**Before the Commissioner / Hearing Panel  
appointed by Canterbury Regional Council**

**IN THE MATTER OF** Applications CRC170651  
to CRC170662,  
CRC184147, and  
CRC182535 to  
CRC182631 by  
Rangitata Diversion  
Race Limited for  
consents to Use land for  
earthworks, vegetation  
removal, the drilling, or  
disturbance of the bed of  
a river; and abstraction,  
damming, use and  
storage of water; and the  
discharge of  
contaminants to land,  
water and air.

**Section 42A Officer's Report**

**Report of Natalia Ford**

**Figure 5 - Modelled embankment failure locations (taken from Figure 3-1 of Klondyke Storage Proposal – Dam Break Report (August 2016))**

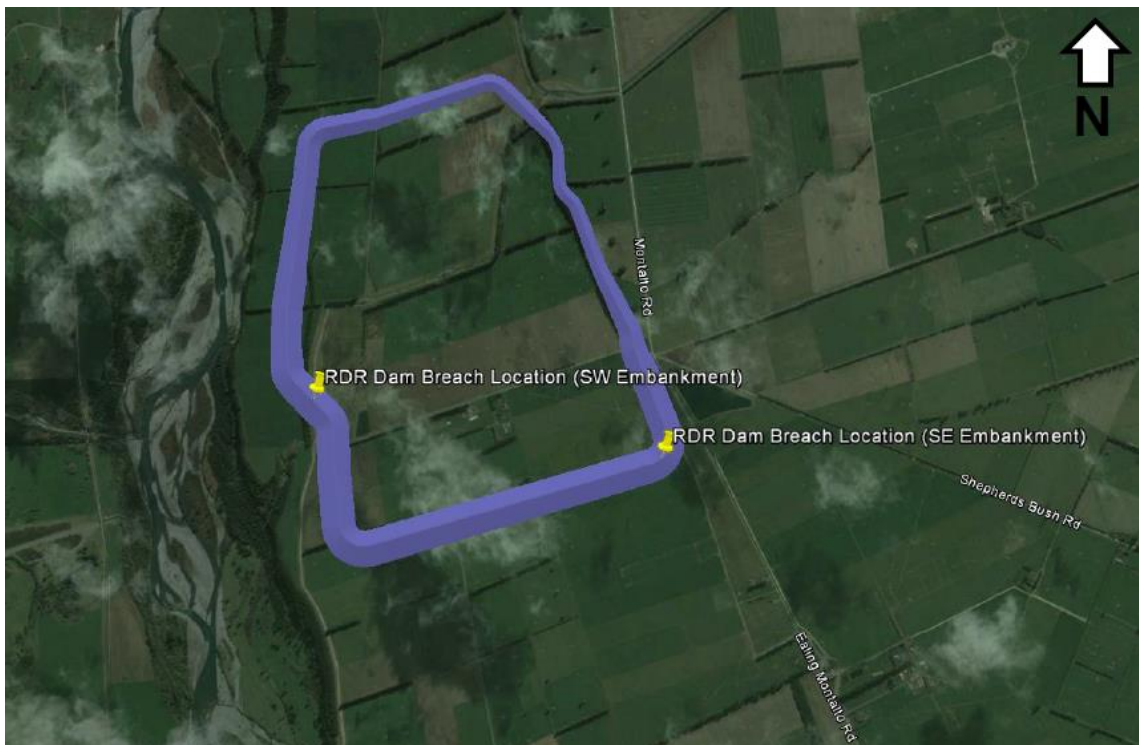
182. Mr Morris considers that these locations are appropriate however a potential dam failure may initiate at other positions.
